Figure 64-19 (new)

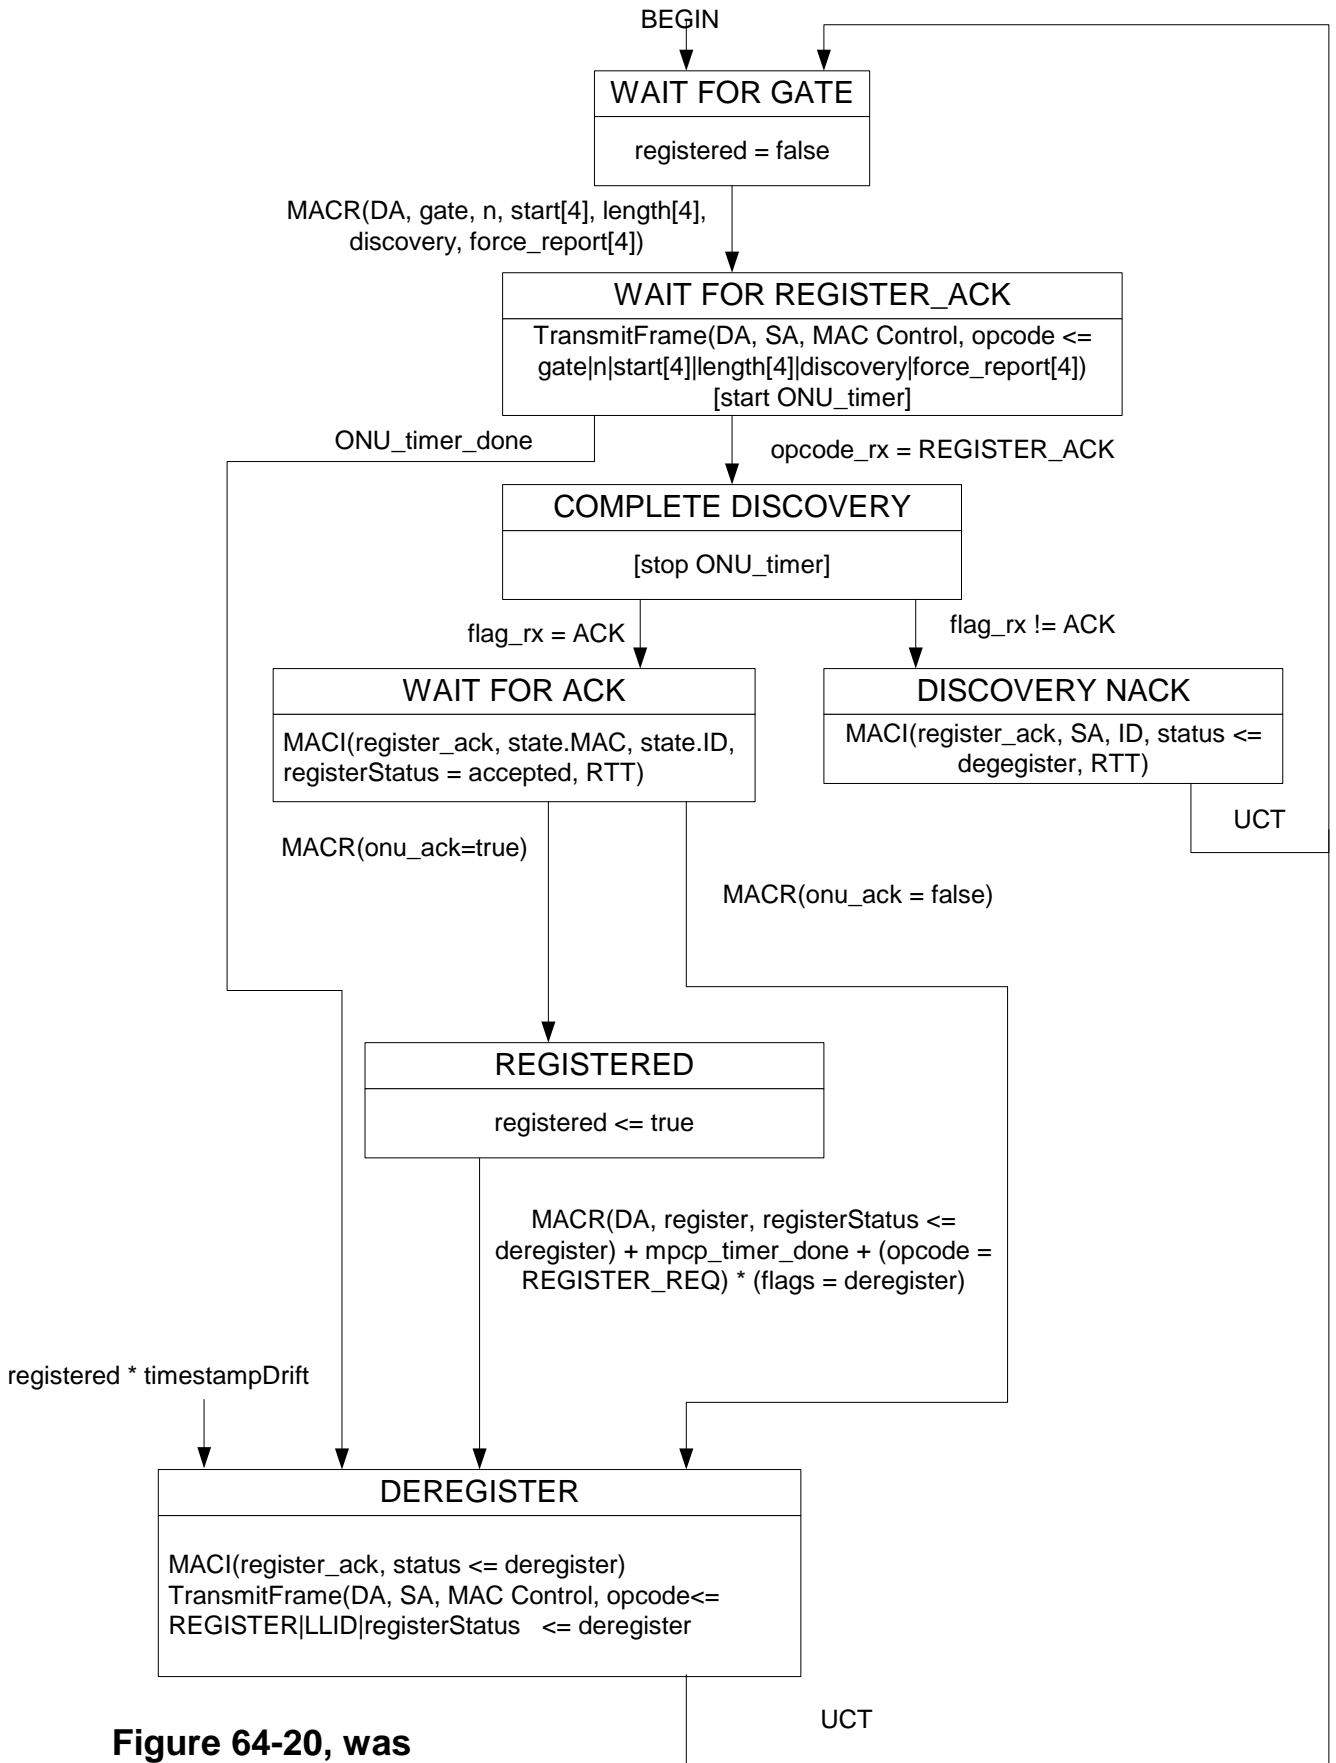
**Figure 64-20, was
Figure 64-19**

NOTE: Need to define MACR(ack) or similar primitive. This comes from the client and says whether or not the ONU's register ack is acceptable.
